Monticello Nuclear Generating Plant
2807 W County Rd 75
Monticello, MN 55362

Subject: Maximum Extended Load Line Limit Analysis Plus License Amendment Request - Request for Additional Information Responses for TRACE/TRACG Differences (TAC ME3145)

**RESPONSES TO NRC REQUEST FOR ADDITIONAL INFORMATION
DATED OCTOBER 4, 2012**

**RESPONSES TO NRC REQUEST FOR ADDITIONAL INFORMATION
DATED NOVEMBER 8, 2012 – NON-PROPRIETARY**

Figure 2-1. Axial Conduction Controlled Quenching

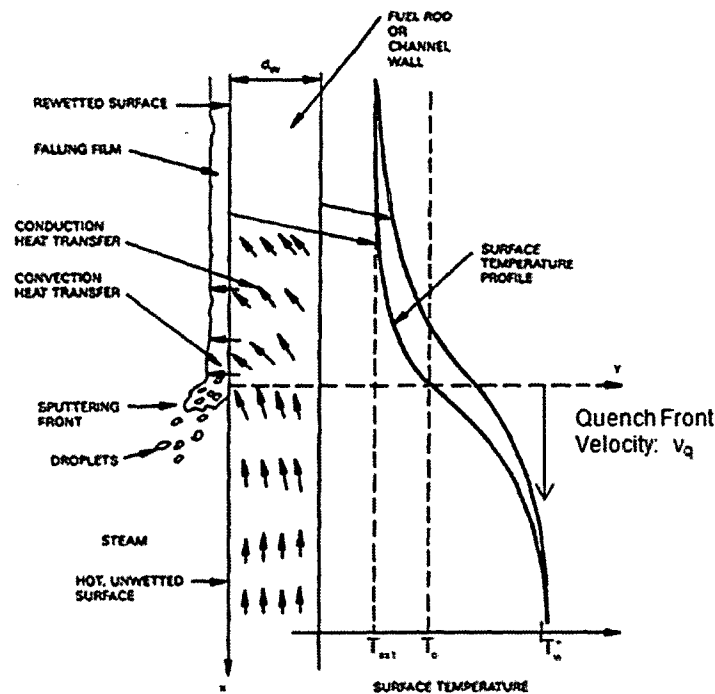
Provide a detailed description of the TRACG implementation of the quench front model.

Provide a numerical comparison of the heat transfer coefficients used by TRACG downstream of the front and “normal” coefficients in nucleate boiling.

The TRACG model for the axial conduction controlled quench front propagation is documented in the TRACG Model Description (Reference 2-1) Section 6.6.13. It simulates the one- and two-dimensional solutions of References 2-2 and 2-3 and was retained from TRAC-P1A (References 2-4, 2-5, 2-6), which was the starting point for the development of the BWR versions of TRAC and TRACG. The model is based on a solution of the two-dimensional heat conduction in the cladding around the quench front location. Figure 2-1 is an illustration of the temperature profile and heat conduction at a quench front.

Ahead of or downstream of the quench front the wall is in film boiling at a high temperature T_w^+ , the wall surface temperature is equal to the quench front temperature T_0 at the quench front, and behind or upstream of the quench front, the wall temperature quickly approaches the saturation temperature. Heat is conducted axially in the wall due to the temperature gradient from the downstream to the upstream region, and outwards to the liquid in the upstream region. The quench front model

correlates the total heat transfer to the liquid upstream of the quench front due to this heat transfer at the quench front. The total heat transfer per unit perimeter to the fluid behind quench front due to the two dimensional heat conduction in the cladding, axially from the dry to the quenched regions and radially to the fluid in the in the quenched region, is given by Equation 2-1.
